ADDENDUM NO. 5

**REQUEST FOR PROPOSAL (RFP) No. 2024-002
TOWN OF GOLDEN BEACH
CONSTRUCTION OF WELLNESS CENTER**

Date of Addendum: February 20, 2025

STUCCO ASSEMBLY STUCCO OVER CMU W/ INSULATION

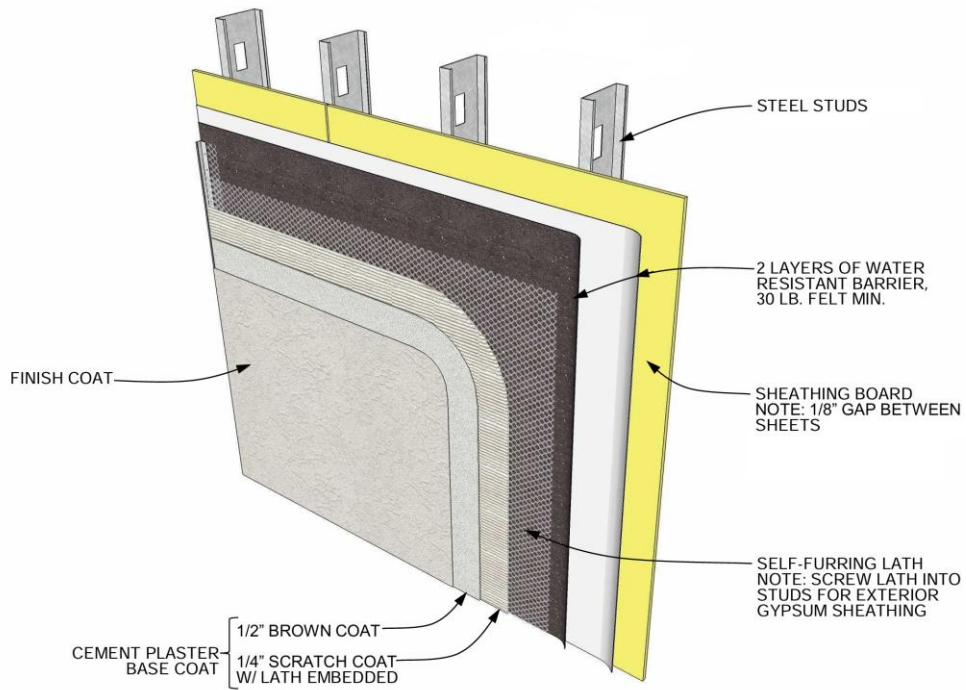
- 1.- There is stucco finish in the exterior part, it shows as 3 coats of it. What type of stucco is it?
- 2.- What level should be interior finish be?
- 3.- in the exterior part of the project there is a metal lathe shown or metal furring. Could you provide some details regarding it?

- 1. Level 1 (Smooth exterior finish) Follow IMI guidelines. www.imiweb.org
- 2. See above.
- 3. See below details.
